RRP Service Bulletin No: RRP SB366

Title: Vent Valve on Graco Grease Pump Installation

Product Series: Advanced Tie Plate Inserter [ATPI]

Summary: Install Lube Remote kit#793110 to add missing vent valve for proper functionality of the grease pump.

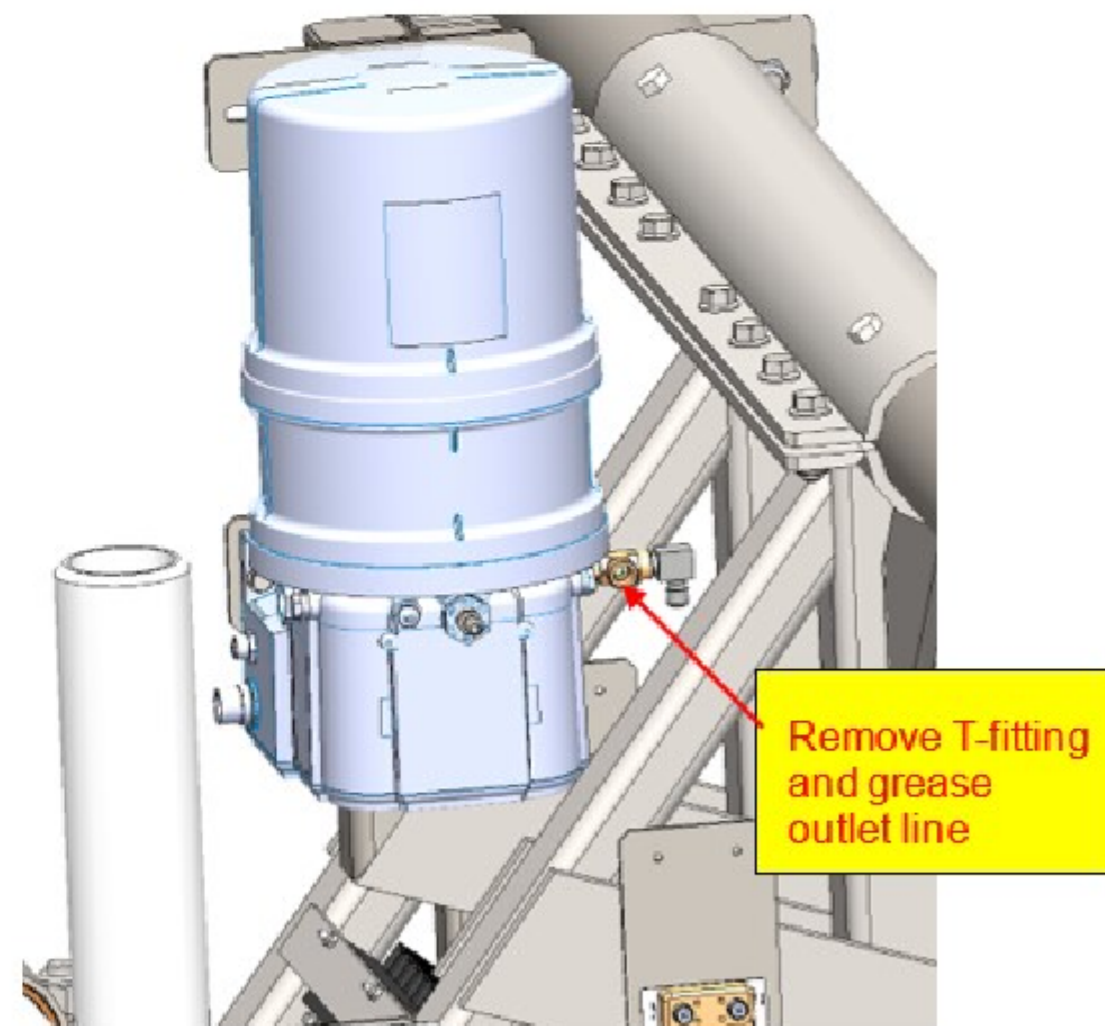
*Before proceeding with installation of vent valve, disconnect the tee fitting and grease outlet line from pump (see below)

FIG. 2

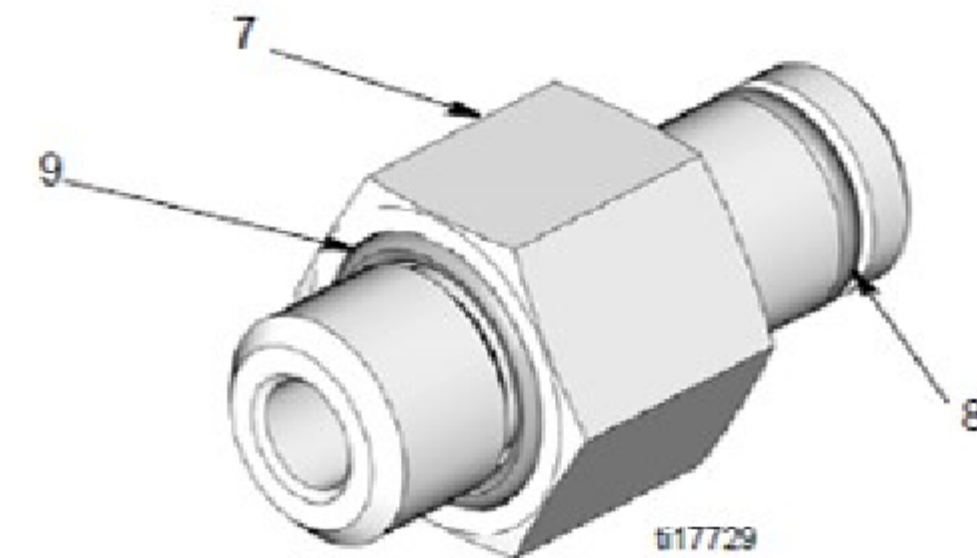
3. Be sure the two o-rings (8, 9) are correctly installed on the bolt (7) as shown in FIG. 2.

FIG. 3

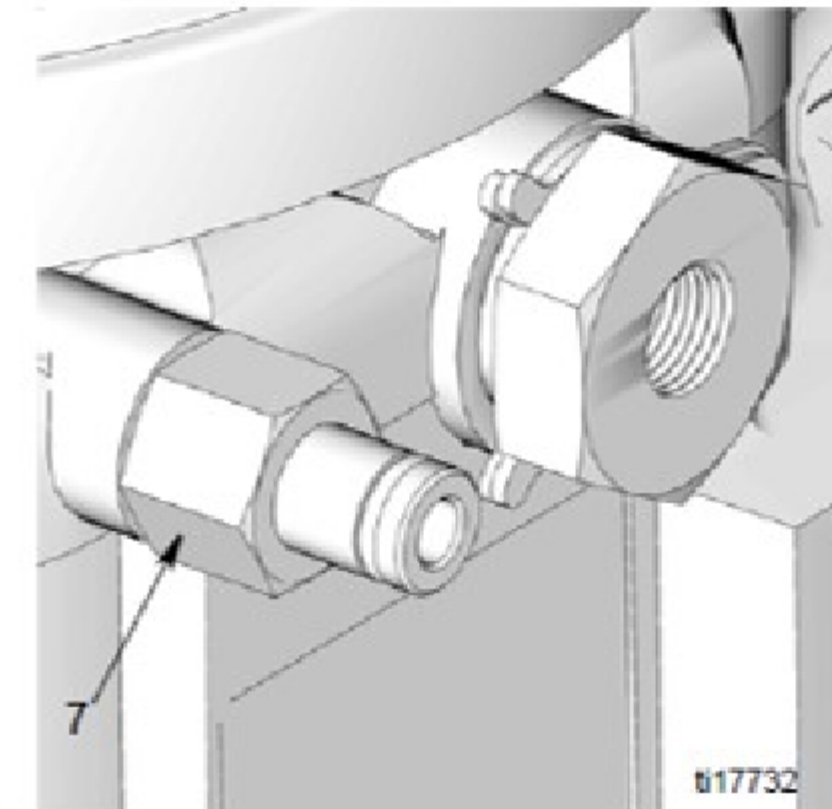
4. Remove plug from G3 and install vent valve alignment bolt (7) in it's place as shown in FIG. 3. Torque to 30 in. lbs. (0.2 N.m).

FIG. 4:

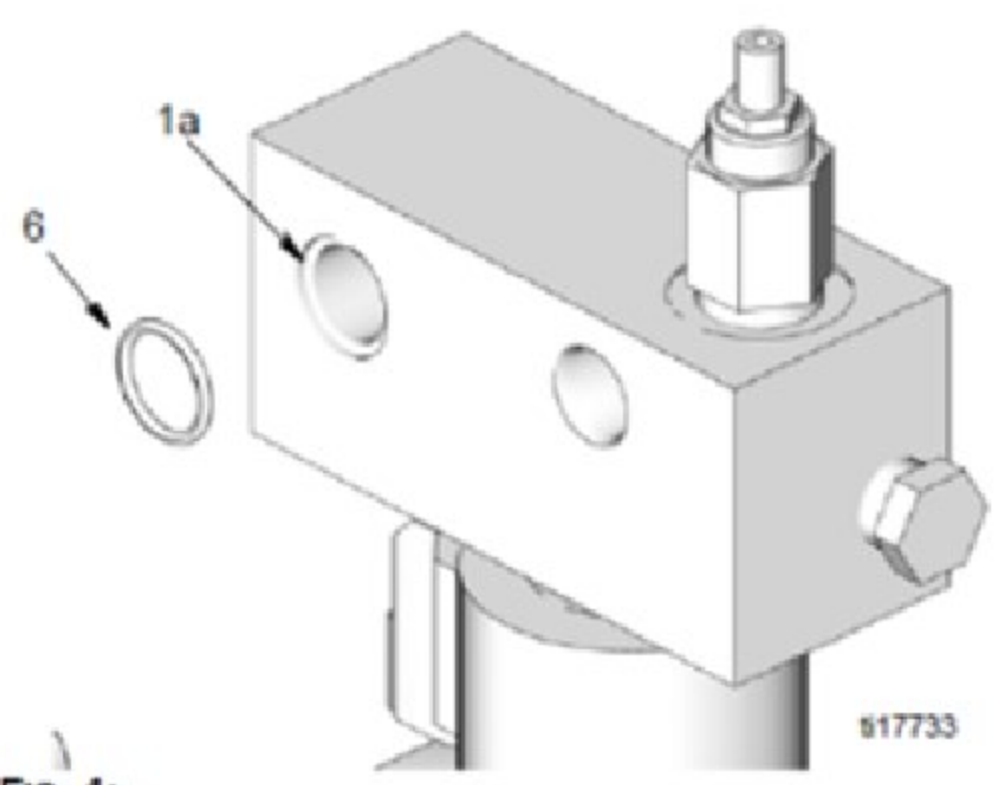
5. Grease o-ring (6) and install in block opening (1a) as shown in FIG. 4.

FIG. 5: Right Side Installation Shown

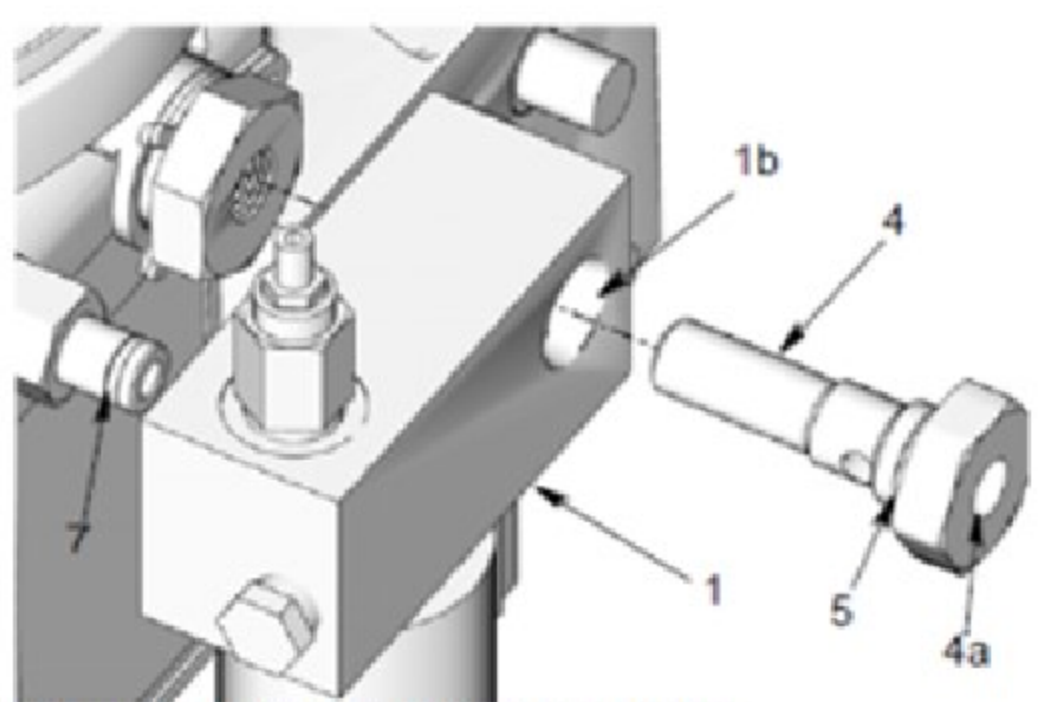
- 6. Be sure o-ring (5) is installed on bolt (4) as shown in FIG. 5.
- 7. Install vent valve mounting bolt (4) through hole (1b) in block (1) and into G3 pump (FIG. 5). Tighten mounting bolt (4) securely then torque to 35 ft. lbs. (47.45 N.m).

NOTE: System connection is made through primary outlet (4a).

FIG. 7

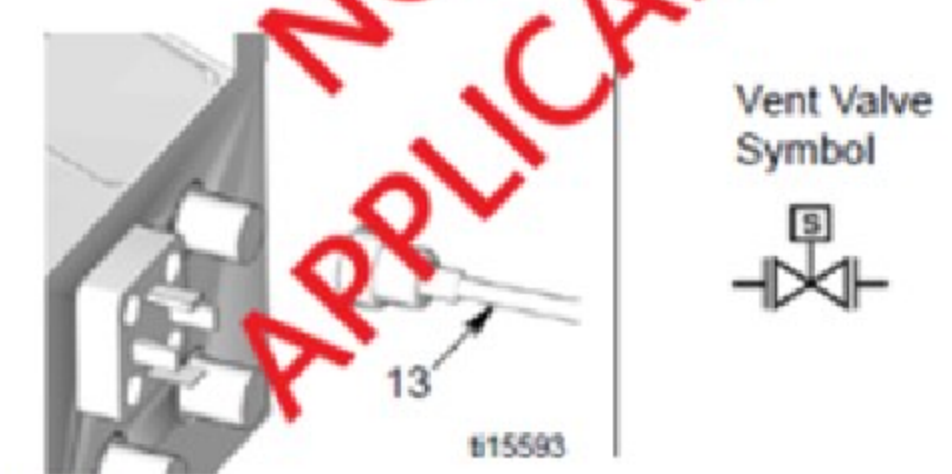
9. Connect end of cable (13) to the G3 (FIG. 7).

NOTE: To verify the correct port on the G3 is selected, locate the symbol shown in FIG. 7 on the G3 label.

Step2: Replacing current harness with new harness (supplied)

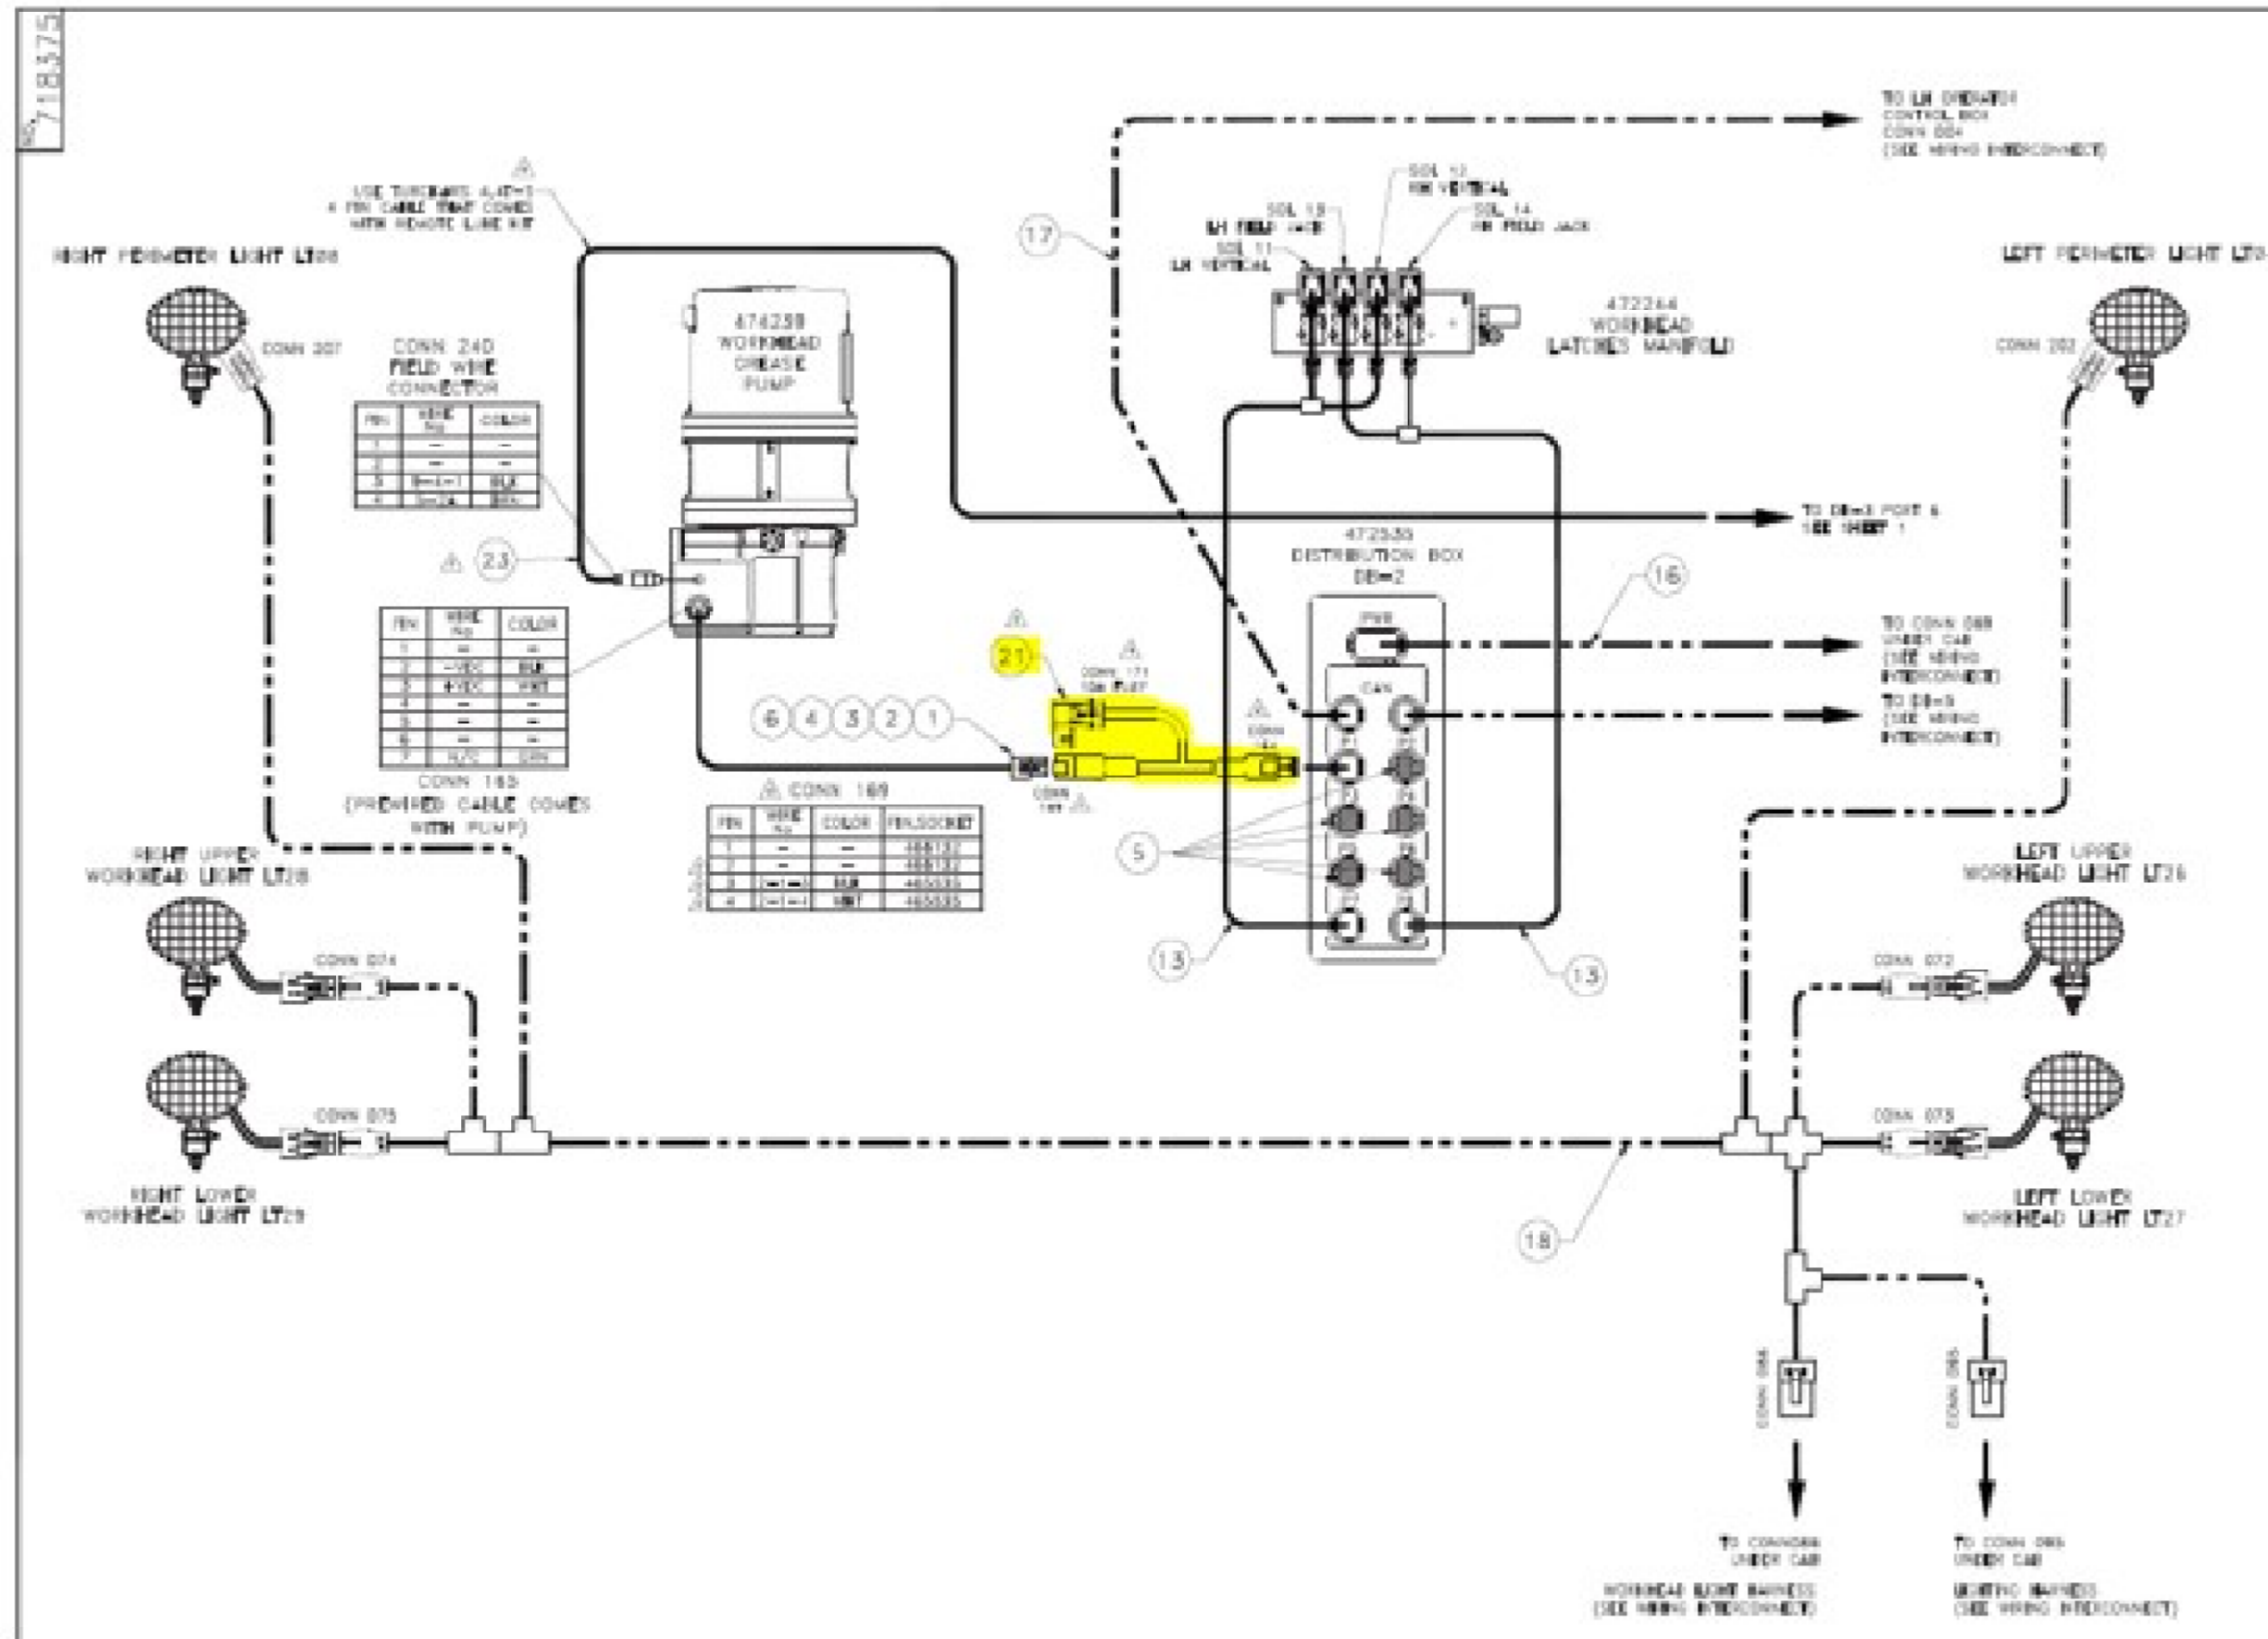
Remove existing harness currently wired to DB2 and grease pump (item 21, highlighted in yellow below)

Replace/connect with new harness supplied (RRP#719722) as shown below:

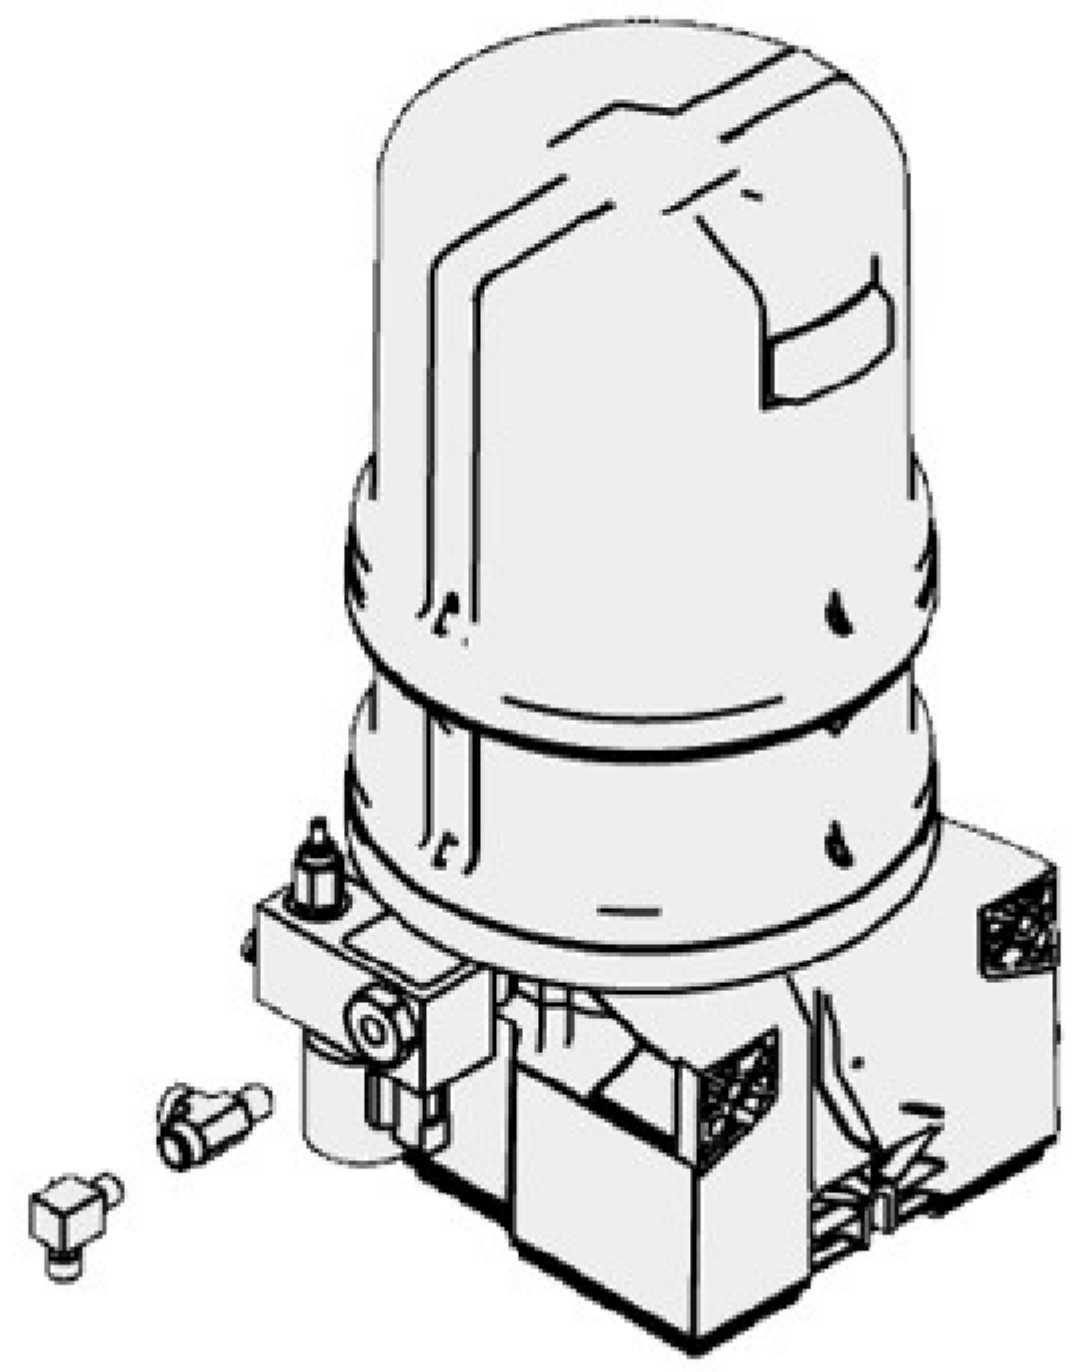
Step3: Re-install the T-fitting and the grease outlet line (removed in step 1) onto outlet element on vent valve (as shown below)
